**TOWN OF NEWBURGH
PLANNING BOARD
TECHNICAL REVIEW COMMENTS**

PROJECT NAME: NEWBURGH COMMONS
PROJECT NO.: 23-24
PROJECT LOCATION: SECTION 9, BLOCK 1, LOT 53.1 & 13
REVIEW DATE: 10 MAY 2024
MEETING DATE: 16 MAY 2024
PROJECT REPRESENTATIVE: JMC PLANNING ENGINEERING

RE: JMC Project 17160
 Newburgh Commons
 Route 9W
 Town of Newburgh, NY

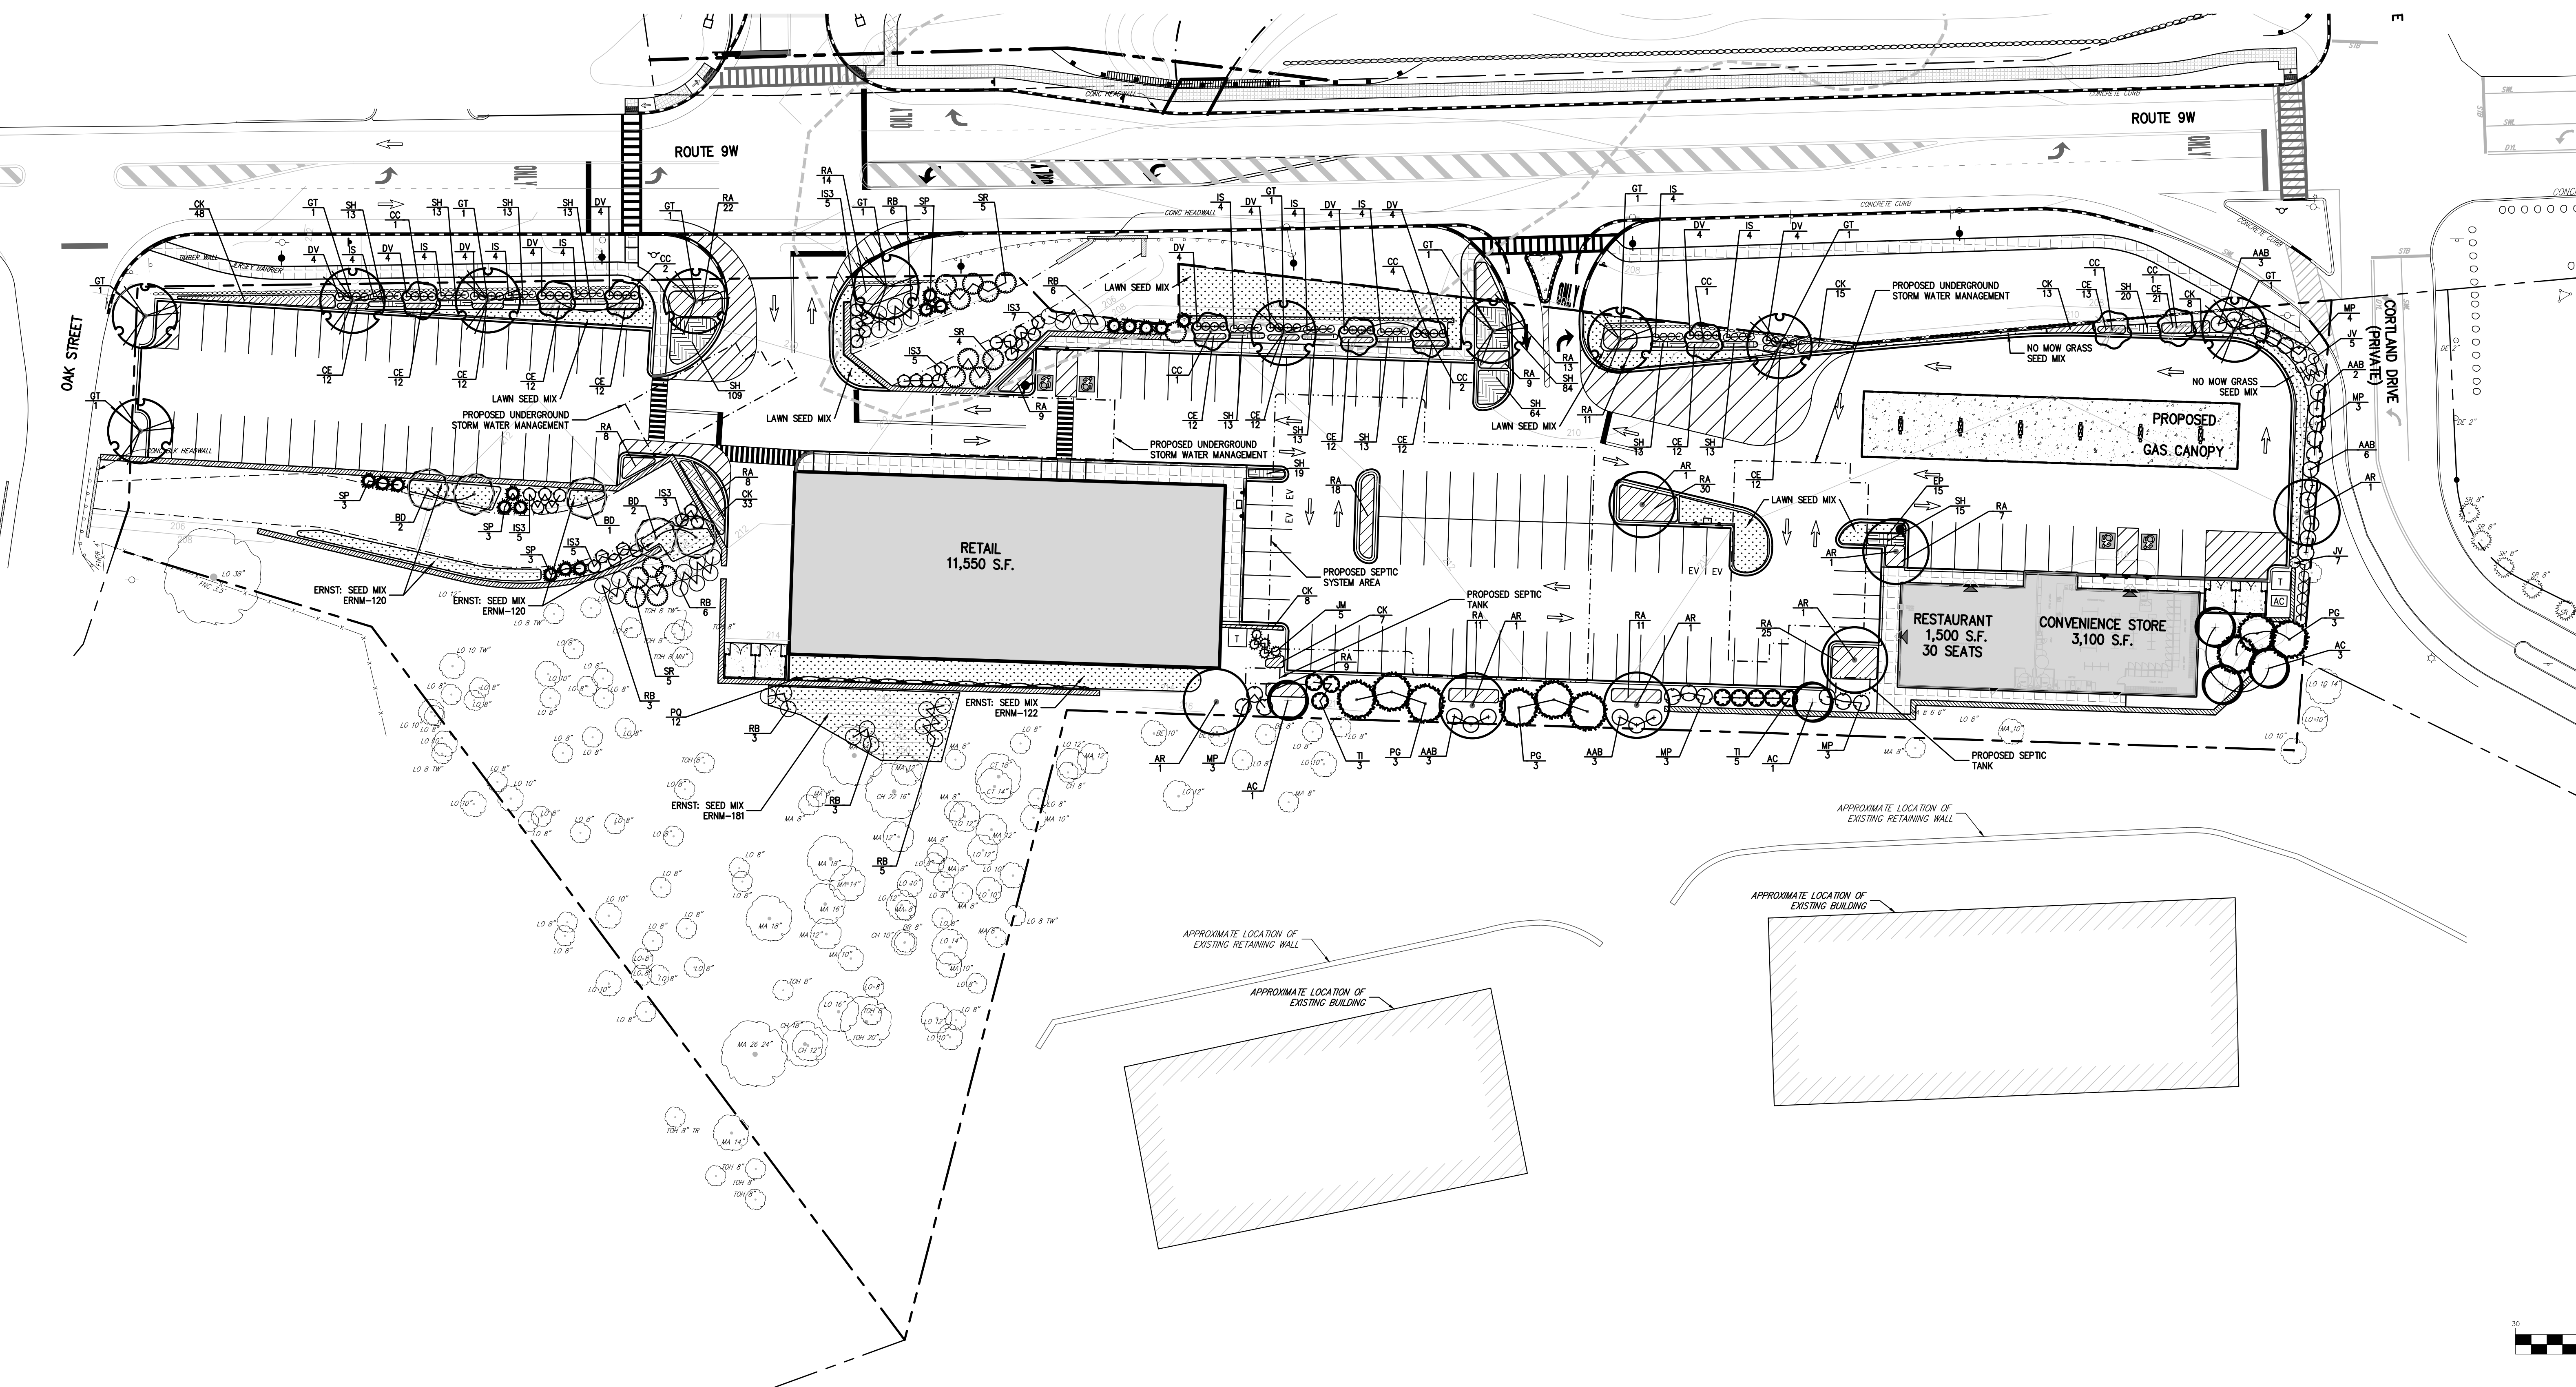
The landscape plan has been revised to include evergreen trees, deciduous trees, and a variety of shrubs along with climbing vines to visually soften and screen the wall and southern property line. Vines are also proposed behind the retail building.

More trees and shrubs need to be added to planting islands. This is a very empty parking lot. Trees are needed to shade cars in the parking lot and offset tree removals proposed to build the project. At least four additional shade trees can and should be shown in parking islands and empty planting beds in front of proposed buildings on site. The trees will also help soften views of the huge retaining walls.

The location of the proposed dry laid stone wall on the north side of the northern entrance leaves an awkward empty gap between the wall and proposed plantings. Please expand the planting to meet the wall to avoid large bare mulched areas that will become overrun with weeds.

Densely plant shrubs beneath the Honey Locust tree proposed at the entrance to the site across from the proposed retail building. There is no reason for a large bed of mulch beneath the tree.

Show another shade tree on the other side of the Oak Street site entrance to help provide shade for the parking lot.

There is an area along Route 9W where plantings have been proposed outside of the property line. We are not sure that this will be deemed acceptable by NYDOT, however, visually it is of benefit to the Town.

The landscape plan has been revised to include (3) deciduous trees in the islands. The number of trees within the parking area is somewhat limited so as not to conflict with proposed subsurface drainage and septic systems.

The landscape plan has been revised to include shrubs, perennials, and ornamental grasses, as well as flowering trees. The plantings will run to the wall on the inside of the property. Additionally, low growing shrubs and ground covers have been added under trees to eliminate large mulch areas.

The Landscape Plan has been revised to include low growing chokeberry under the locust trees at the entrance and various islands in the parking lot minimizing the amount of mulch area.

The Landscape Plan has been revised to include (2) shade trees at the west area of the parking lot along Oak Street.

The Landscape Plan has been revised to reflect no planting within the NYSDOT right-of-way.

The above warrantee note has been added to the Landscape Plan as note 19.
